# NATIONAL RADIO COMPANY, INC.

## CUSTOMER SERVICE BULLETIN

NCX-3 ADDENDA SHEET

NCX-3  
CSB 66-2

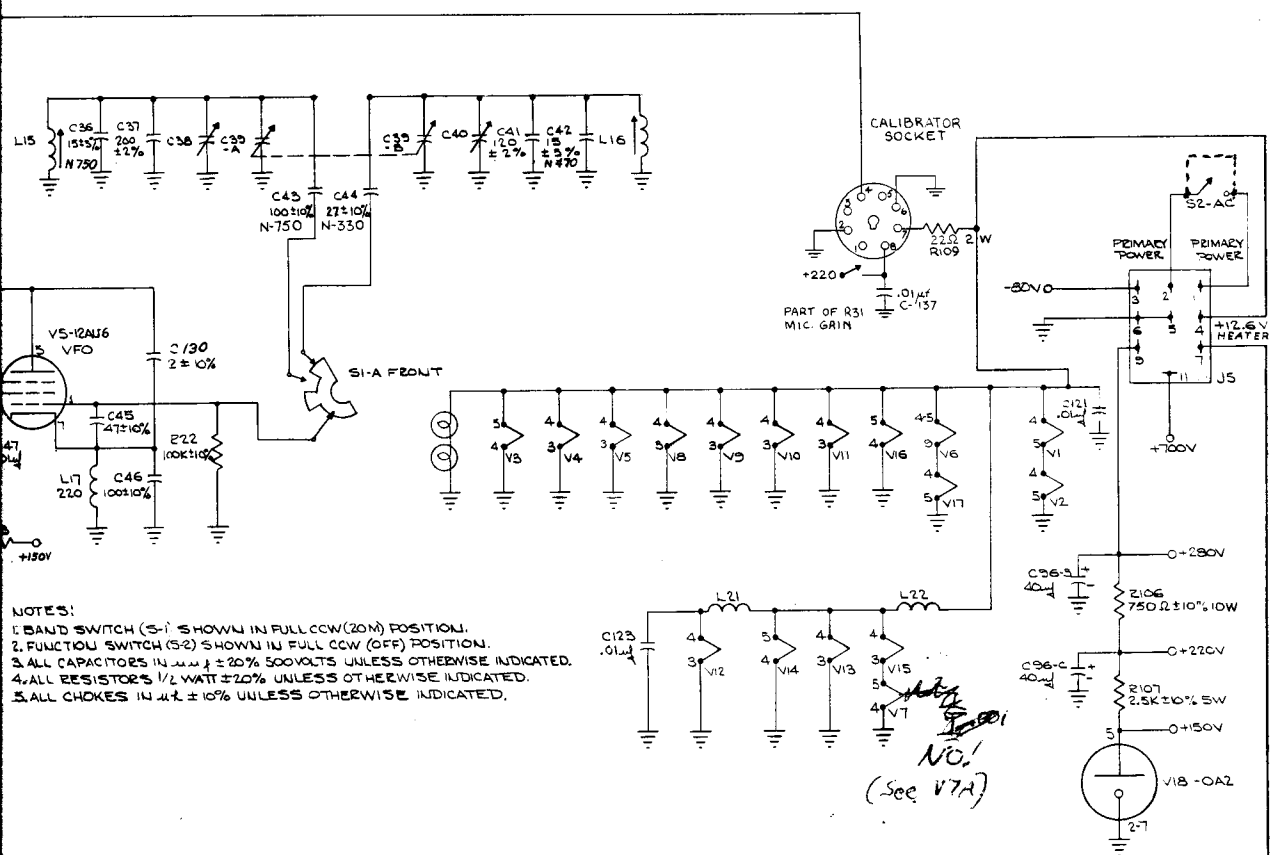
\* R44 removed per letter from National

MODEL NCX-A

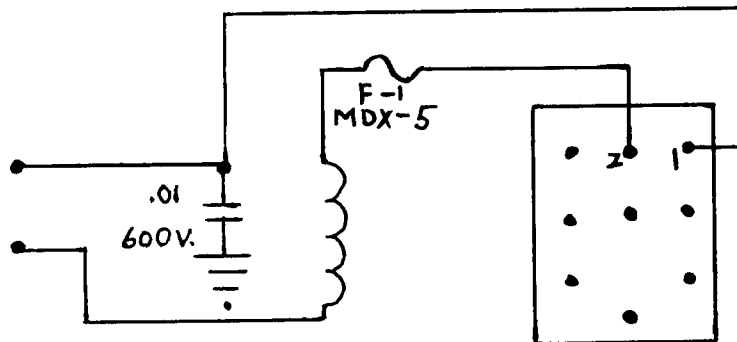
1. Resistor R7 has been changed from  $1000 \Omega \pm 10\%$  to  $1800 \Omega \pm 10\%$ .
2. A  $0.01 \mu\text{f}$  600 volt capacitor from one side of the AC line to chassis is not indicated on the schematic.
3. A revised primary power schematic is shown below:

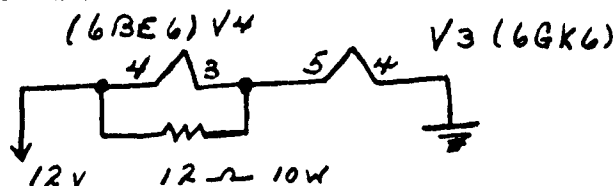
Change C-18 from 240pf to 220pf 5%. Repeak 80 meter driver coil.
